# **Intel<sup>®</sup> Mobile Pentium<sup>®</sup> II Processor Specification Update**

Release Date: February 2001

Order Number: 243887-029

Old Mobile Pentium® II Processor in Mini-Cartridge Package Label with Supplier Matrix Mark

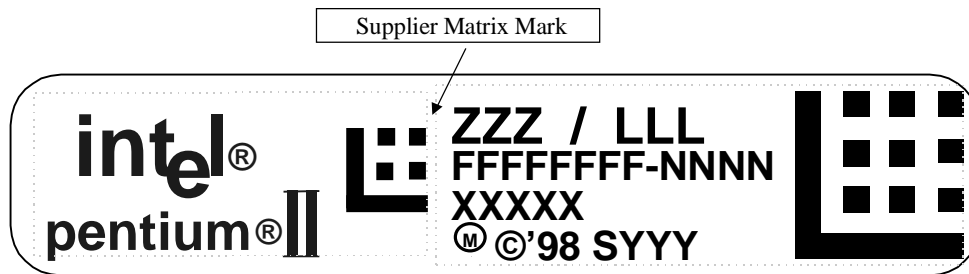
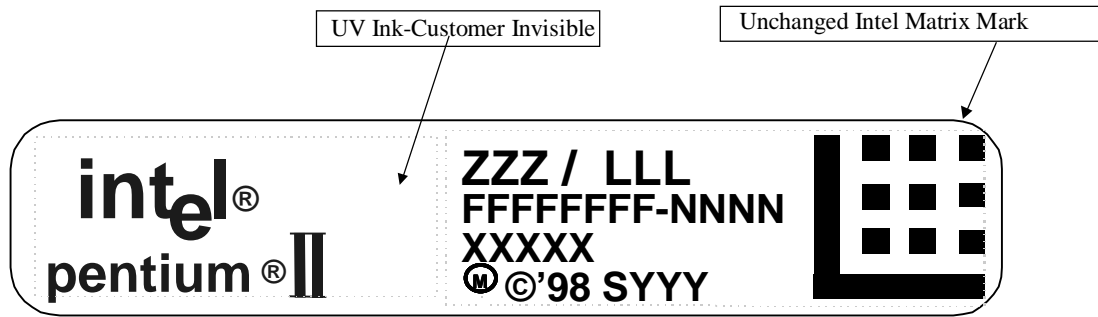
New Mobile Pentium® II Processor in Mini-Cartridge Package Label with Supplier Matrix Mark Removed

Figure 2. Workaround Flowchart: SMBALERT#-Driven System

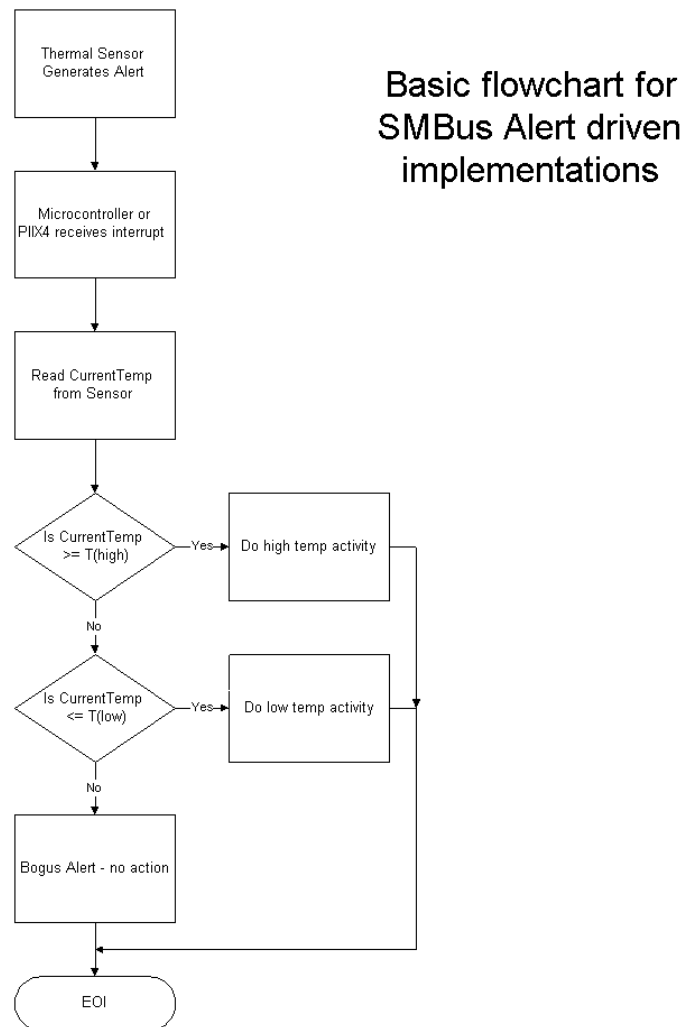
**Problem:** The Mobile Pentium II processor and the Pentium II Processor Mobile Module have a thermal sensor that monitors the processor core's temperature. Please note that desktop systems could have a similar thermal device. The thermal sensor asserts SMBALERT# if the processor temperature exceeds the temperature limits set in the Alarm Threshold Registers ( $T_{HIGH}$ ,  $T_{LOW}$ ). It also sets the corresponding Status Register bits to identify the cause of the interrupt. Figure 1 gives one example of the how the SMBALERT# signal could be used in a system.

Under the conditions described below, the thermal sensor incorrectly generates the SMBALERT# interrupt. All of the following conditions must be met to trigger a false interrupt:

1. Before servicing an interrupt from the thermal sensor, read and compare the processor thermal reading with the threshold limits ( $T_{HIGH}$  or  $T_{LOW}$ ). Figures 2 and 3 provide basic flowcharts for the implementation of this workaround in an interrupt driven system.
2. If the firmware implemented polls the Status Register only, then before taking any action, re-read the temperature register and do a comparison with the alarm threshold limits ( $T_{HIGH}$  or  $T_{LOW}$ ) to determine if the value is actually still within the temperature window.

3. Use a temperature polling scheme to monitor the processor temperature.

**Figure 5.6. Cross Sectional View with Vertical Dimensions**

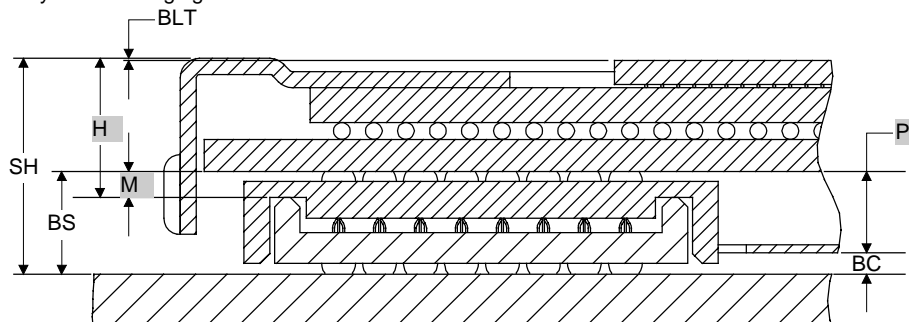
### B1. Mislabeled Vertical Dimension Parameters

Figure 5.6 in the *Mobile Pentium® II Processor at 233 MHz, 266 MHz, and 300 MHz* datasheet should be replaced by the following figure:

**Figure 5.3. Surface-Mount BGA1 Package—Top and Side View**

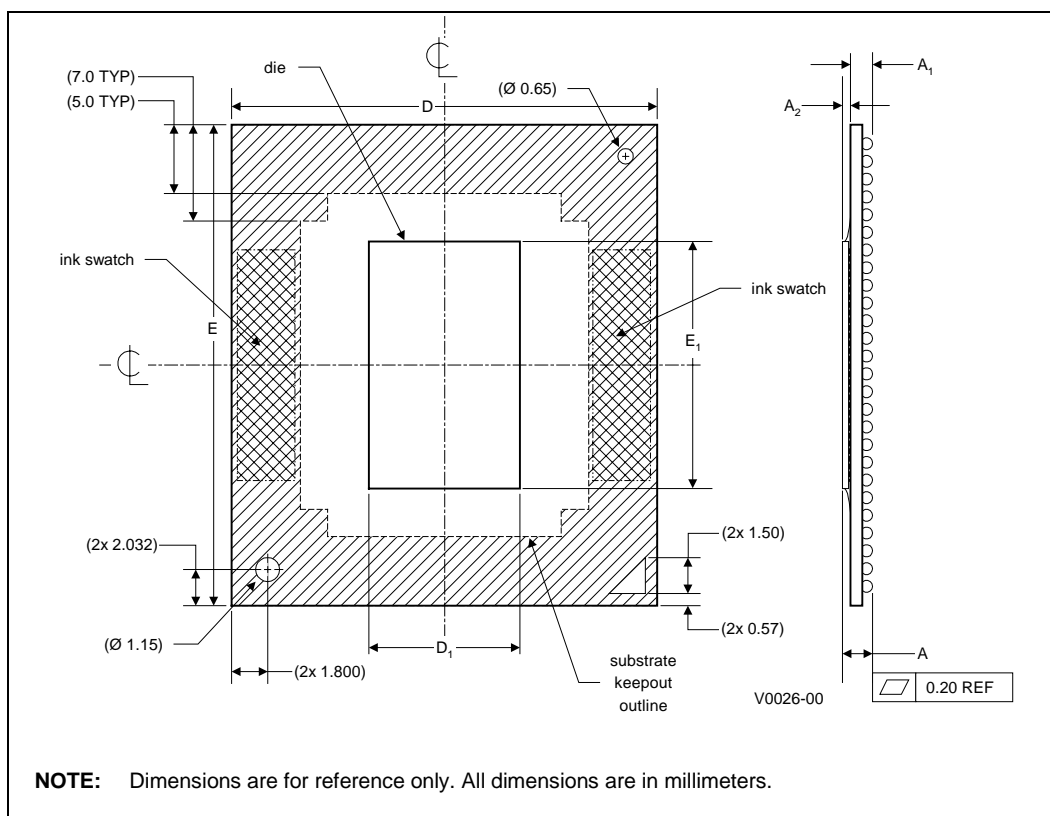
The following table and figures show the updated mechanical specifications for the BGA1 package, listed as Table 5.2, Figure 5.3 and Figure 5.4, respectively, in the *Mobile Pentium® II Processor in BGA Package at 366 MHz, 333 MHz, 300PE MHz, and 266PE MHz* datasheet.

Figure 3.3 Generic Clock Waveform

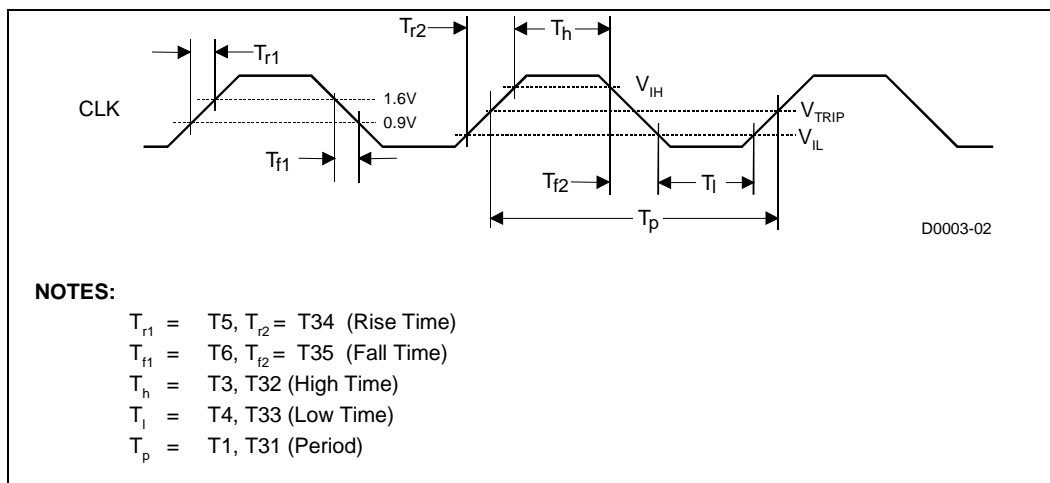
#### B14. Generic Clock Waveform Figure

Figure 3.3 in *Mobile Pentium® II Processor in Mini-Cartridge Package at 366 MHz, 333 MHz, 300PE MHz, and 266PE MHz* datasheet (Order Number 245108), and the *Mobile Pentium® II Processor in BGA Package at 366 MHz, 333 MHz, 300PE MHz, and 266PE MHz* datasheet (Order Number 245106) has been updated. The following figure is to replace the ones in the above documents.

Figure 1. TAP Gageable Thread Clarification

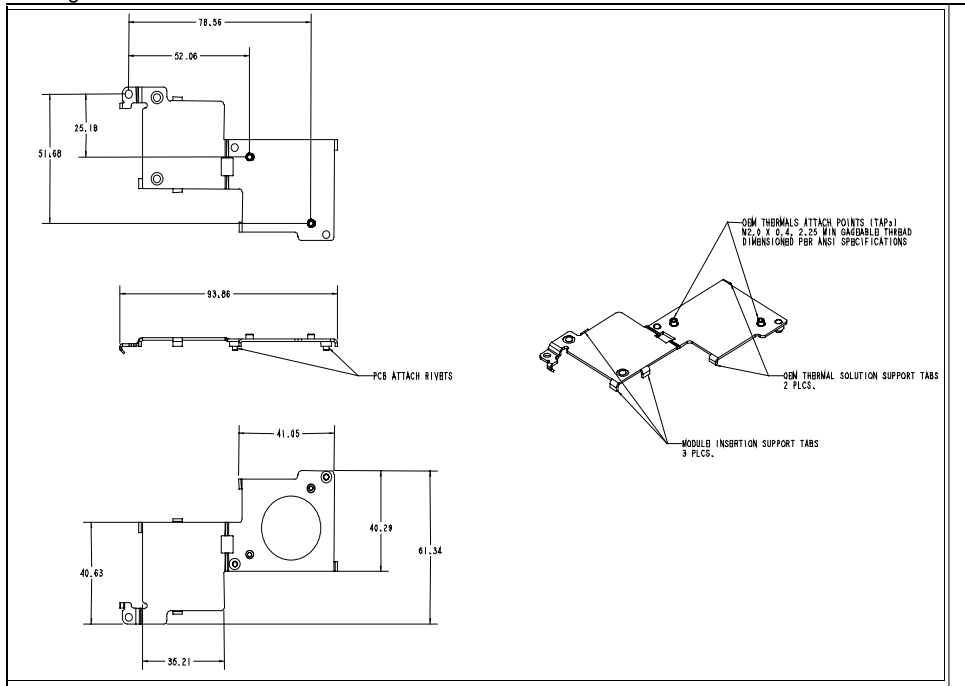
In the *Intel® Pentium® II Processor Mobile Module : Mobile Module Connector 1 (MMC-1)* and the *Intel® Pentium® II Processor Mobile Module : Mobile Module Connector 2 (MMC-2)* datasheets (Order Numbers 243667 and 243668, respectively), the thermal attach point (TAP) gageable thread specification was not clearly identified in Figure 14, of Section 5.2. The following is the TAP clarification:

OEM Thermal Attach Points (TAPs) M2.0 x 0.4, 2.25 min gageable thread dimensioned per ANSI specification.

See Figure 1 below for more information.
